ZONING, PLATTING & ADVISORY COMMITTEE (ZPAC) September 3, 2024 – Approved Meeting Minutes

Petition 24-24 James W. Filotto on Behalf of Oakland Avenue Storage, LLC

Re: Filotto Roofing – Site Plan

SITE IMPROVEMENT PLANS FILOTTO ROOFING US ROUTE 52, MINOOKA

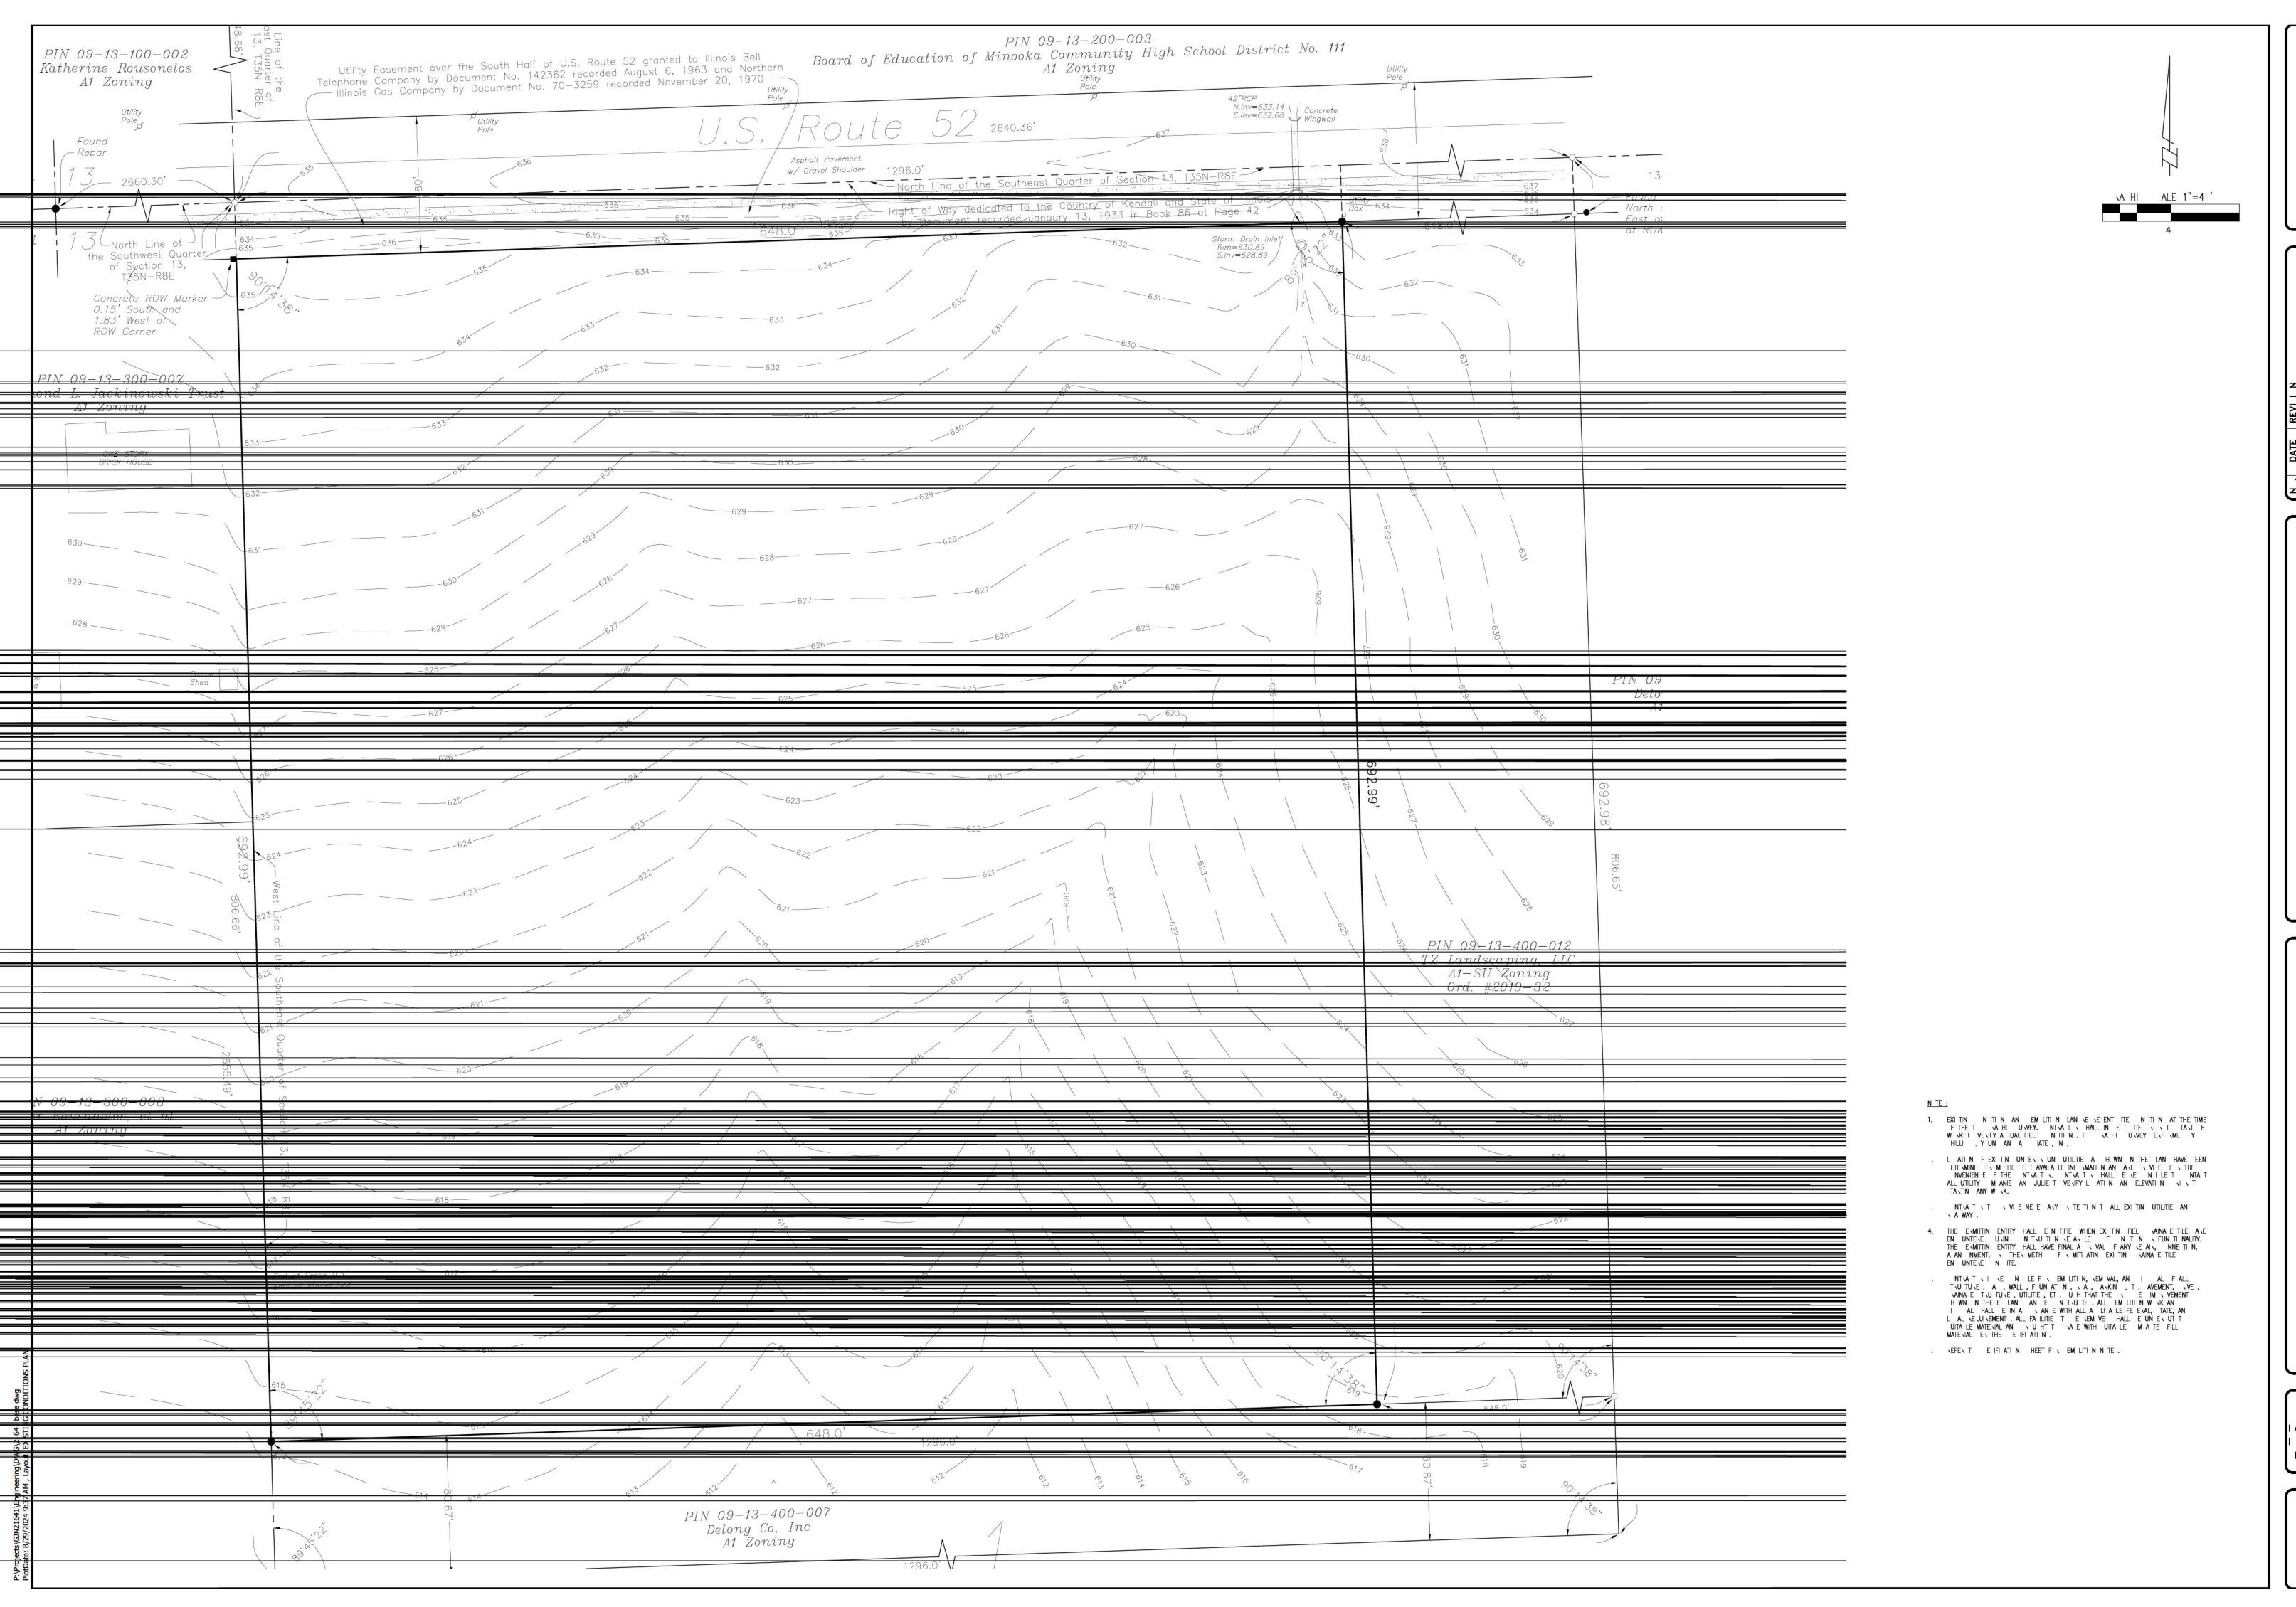
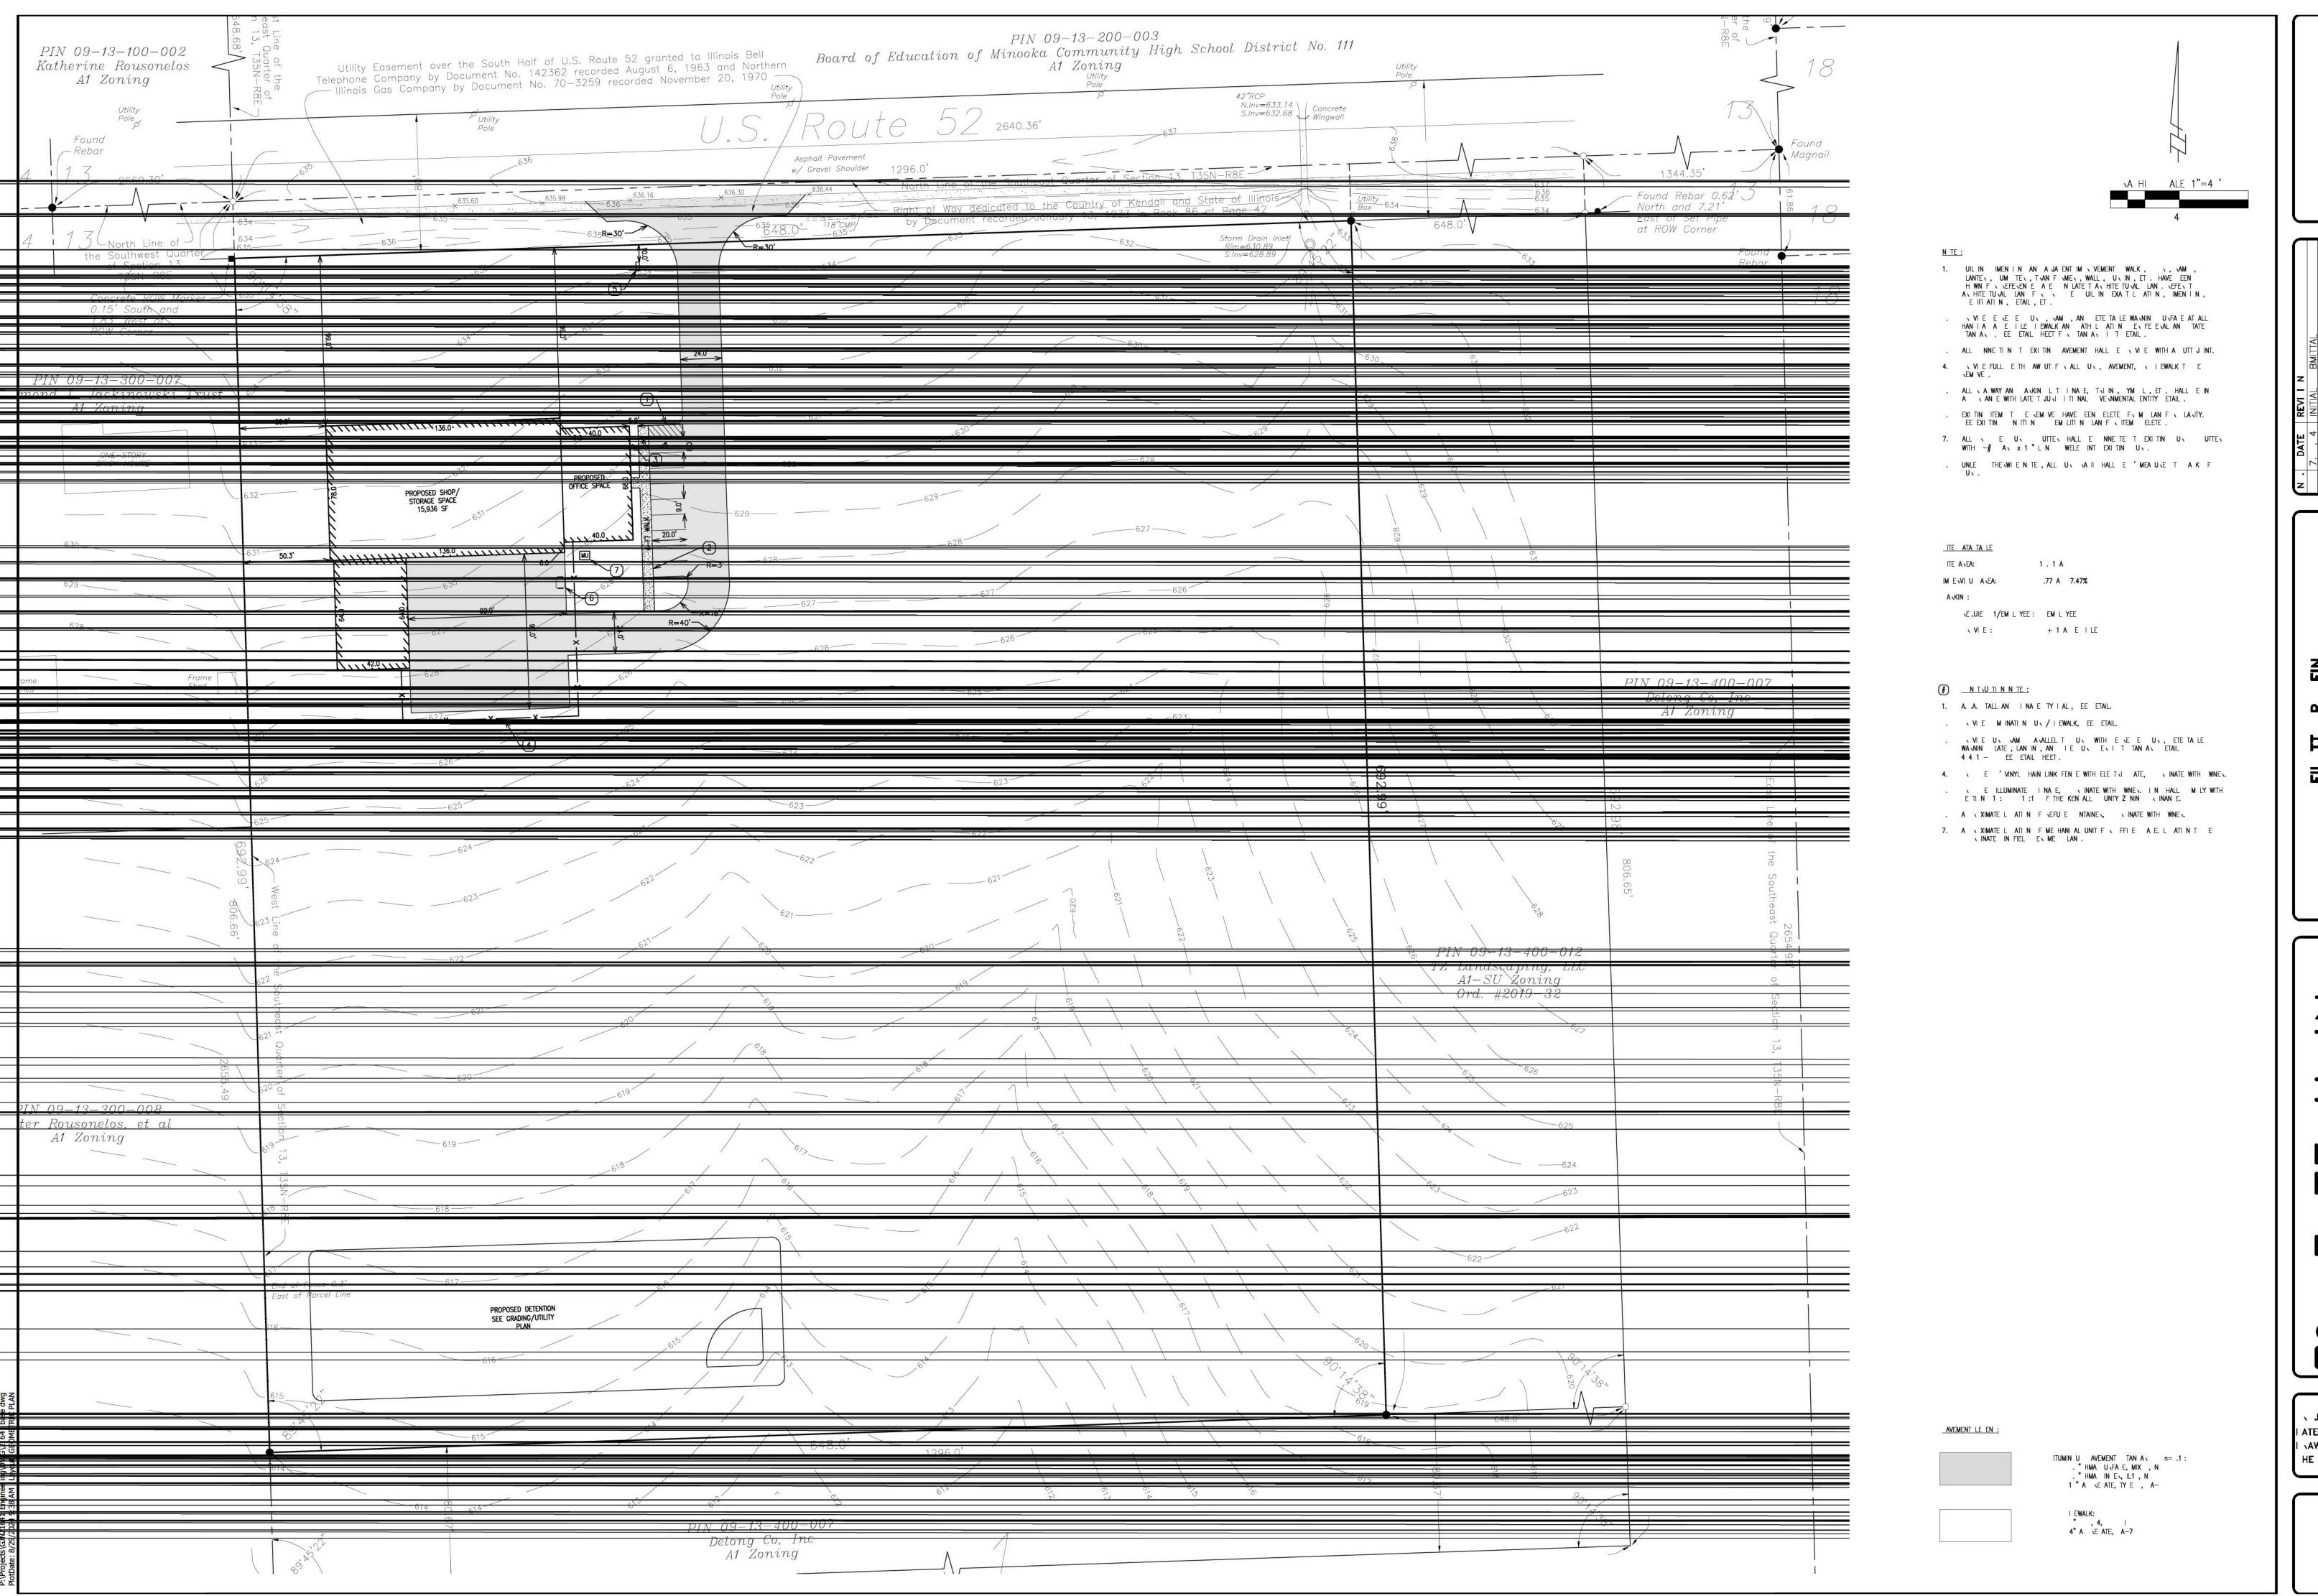
- 1. In the Stormwater Management Report, the Detention Tributary Area exhibit and detention calculations reflect the basin provides detention for the disturbed 2.87 acres, however, in proposed conditions the basin will accept runoff from an additional area between the proposed disturbance and possibly areas north of the proposed building. Please evaluate the overflow weir for this additional flow as to depth and velocity with the understanding overflow conditions will occur more frequently. The overflow weir calculations have been updated to include both the developed area and the undeveloped area that are both tributary to the proposed detention basin.

- 2. The weir coefficient is represented as two different values in the stormwater report. Verify the appropriate value. Also verify the weir length in the calculations matches the plans. **The stormwater calculations have been updated to reconcile the weir coefficients.**

- 3. Site Improvement Plans Please add dimensions to the restrictor manhole detail to verify the minimum 4" clearance will be met with the proposed top of wall elevation. Revise the grate type to maximize the overflow potential using a beehive type or "01" for EJIW products. The rim of the restrictor structure has been raised slightly to accommodate for the extra height of the beehive grate. Also, the restrictor structure detail has been updated to include dimensions to demonstrate that there will be adequate clearance for the top of the wall in the restrictor structure.

- 4. We understand the drainage swales along the east and west limits of the disturbed area are intended to capture flow from disturbed areas and route it to the stormwater basin. The definition of the swale is lacking in some areas. It is preferred that a typical minimum swale section be depicted that call out a minimum swale bottom side slope and depth to convey flows. Verify minimum depth with a channel capacity calculation. It is not necessary to revise all contours or include this additional area in the stormwater calculations, however we have no objection if that is done. Our primary concern is that the final field conditions will indicate clear capture and routing of the flows. Typical swale sections have been added to the Grading Plan. Also, Appendix 5 has been added to the Stormwater Report to demonstrate that the proposed swales have adequate capacity to convey the 100-year tributary flows to the detention basin.
